ISSUE: Permit to Demolish/Capsulate (partial), Certificate of Appropriateness for alterations and signage

APPLICANT: Old Town #1, LLC, represented by Paul Beckman, Architect

LOCATION: Old and Historic Alexandria District
814 King Street, Unit 1

**BAR#2024-00441 & BAR#2024-00447**
814 King Street, Unit 1

3 DEMO - ELEVATION

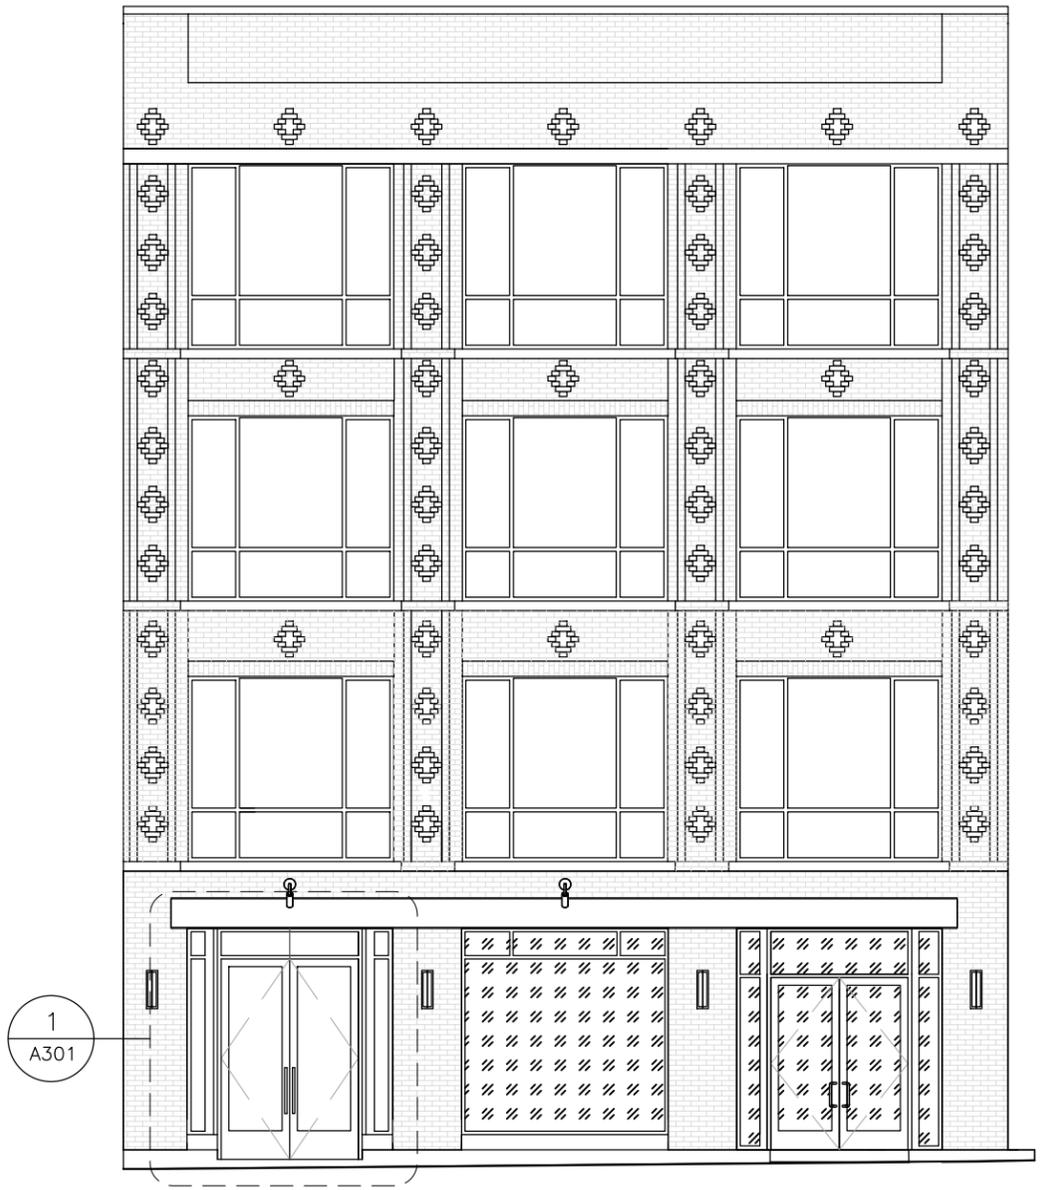
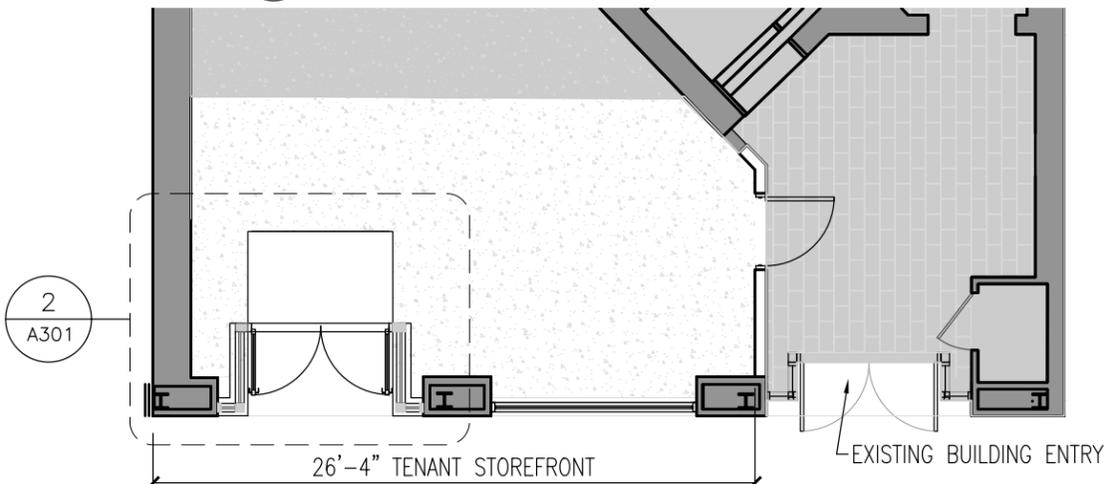
The analysis of the standards indicated above relate only to the portions of the wall area proposed for demolition/capsulation. In the opinion of staff, none of the criteria for demolition and capsulation are met and the Permit to Demolish/Capsulate should be granted. The areas proposed for demolition/capsulation are not of unusual or uncommon design and can easily be replicated. The total amount of demolition is 90ft². Additionally, the demolition will occur in a portion of the wall area that was previously altered.

1 NEW ENTRY DOOR ELEVATION
 A301 Scale: 3/8"=1'-0"

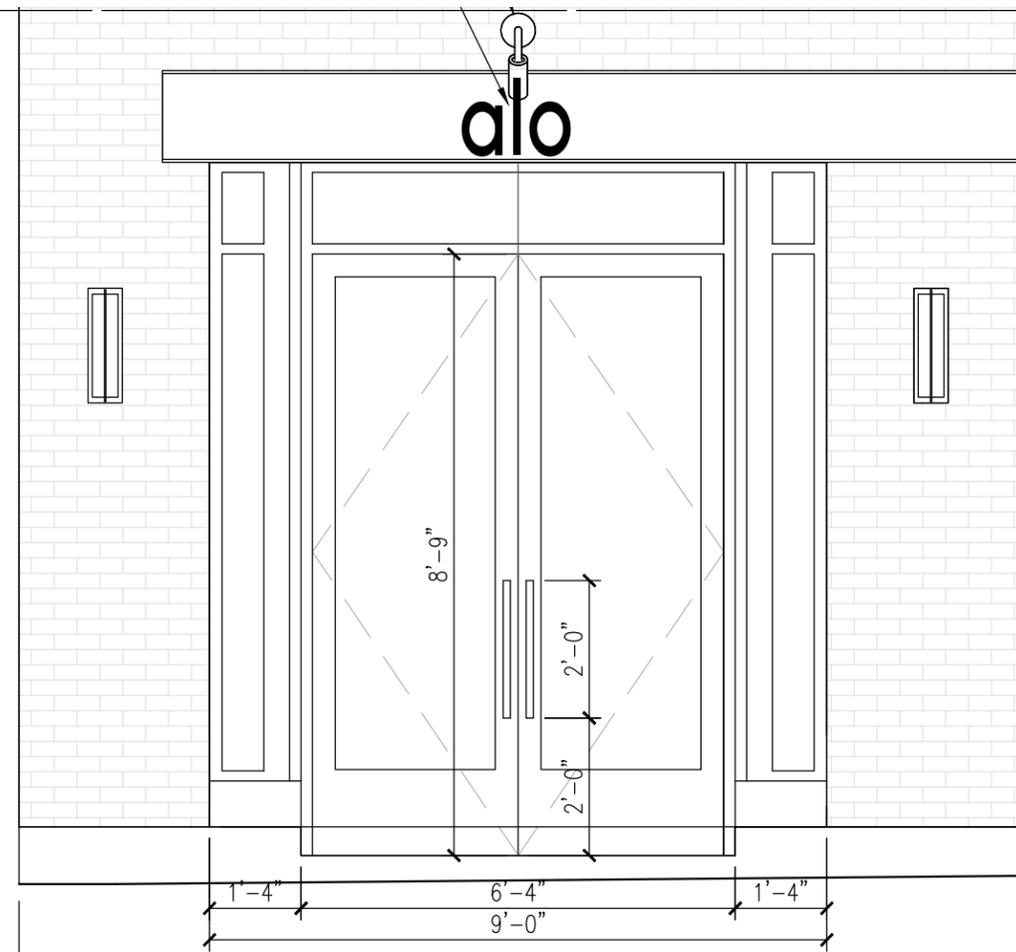
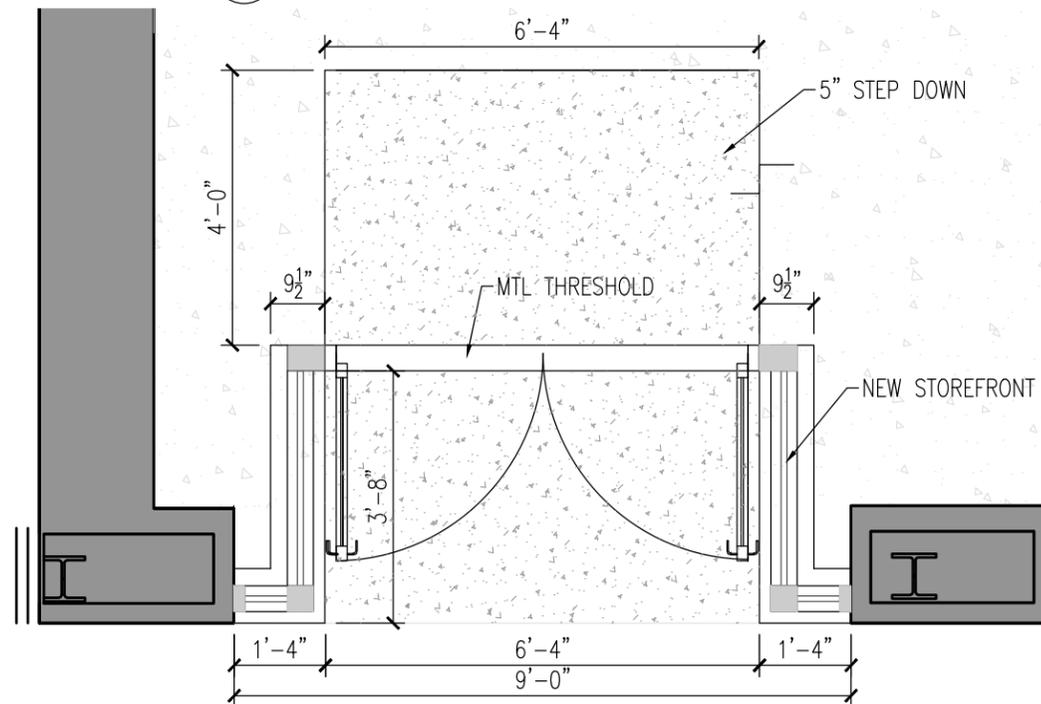
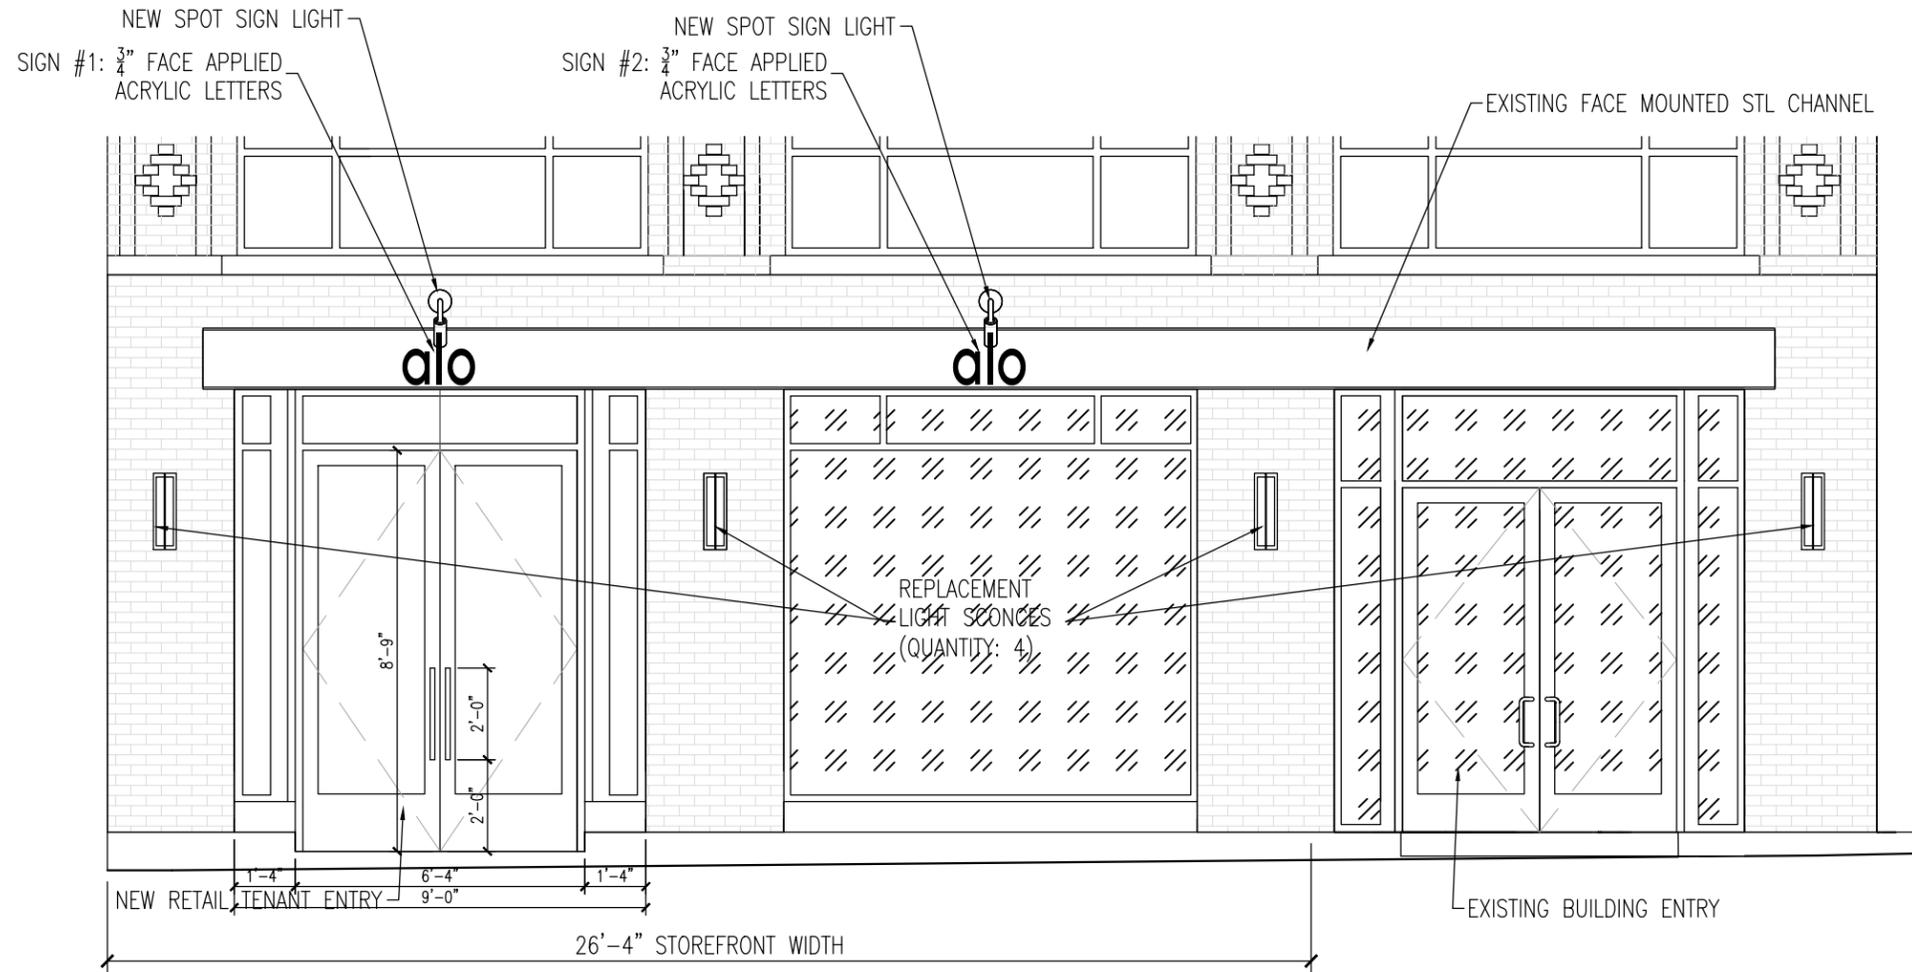
Staff supports proposed storefront entrance to the building, noting that the storefront on the first floor was previously altered and is not original to the building. The new entrance will be fitted within an existing storefront window and will consist of two French doors and a glass surround. The applicant states that the new glazing and door frame will match the existing profile and finish, which is architecturally appropriate for the building. Staff notes that all glazing must be clear glass and in compliance with *BAR's Window Policy*.

1. All glazing must be clear glass and in compliance with *BAR's Window Policy*; and,
2. The proposed wall signs must be non-illuminated.

1 SIGNAGE - ELEVATION
A302 Scale: 1/4"=1'-0"

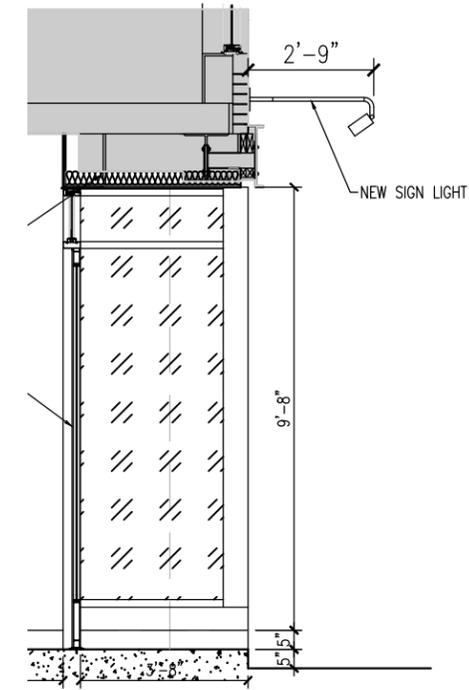
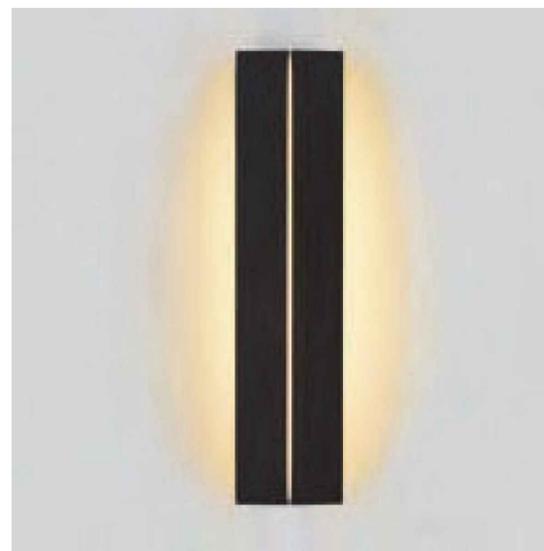
The applicant proposes to install two (2) flush mounted illuminated signs on the existing header beam and install two new spotlights above the signs. The proposed signs will be 3.4 ft² each, for a total of 6.8ft². Staff has no objection to the proposed design, size, or location of the signs. However, staff does not support the illuminated aspect. The *Design Guidelines* encourage signage to be compatible and blend in with the architecture of the building. While in recent years, the Board has approved illuminated wall signage on Late buildings within the district and staff does not believe illuminated signs on Early buildings are appropriate. The proposed spotlights will adequately illuminate the wall signs. With the conditions that the window glazing comply with the *BAR's Window Policy* and the signage is not illuminated, staff recommends approval of the project.
